TECHNICAL UPDATE – ROCKET 3 STORM TRIUMPH SHIFT ASSIST ACCESSORY FITMENT

Central Warranty has issued a Technical Update on all VINS for both the new Rocket 3 Storm R and Rocket 3 Storm GT.

Adjust Shift Force Sensor Shift Pattern

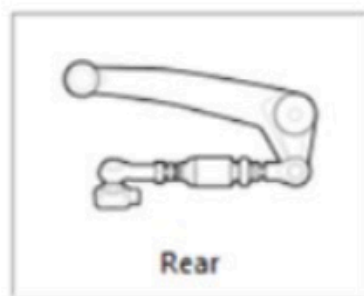
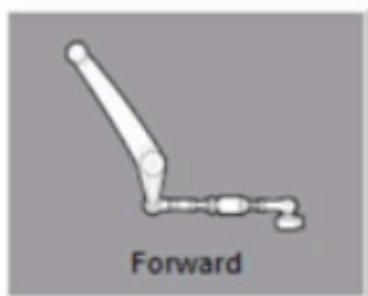
Accessory Triumph Shift Assist (TSA) will not operate when installed and configured with OEM foot controls. Triumph has carried out an investigation of this TSA concern and identified the root cause. We are currently evaluating the next steps for resolution and will update accordingly.

When fitting the accessory TSA, dealers must apply the opposite shift configuration via TDT – for example, select 'Rear' configuration if 'Forward' foot controls are fitted.

The shift configuration can be adjusted using the Triumph Diagnostic Tool. Navigate to Diagnostics -> Engine ECM -> Adjust and select Adjust Shift Force Sensor Shift Pattern. There is no requirement to replace any parts under warranty at this time.
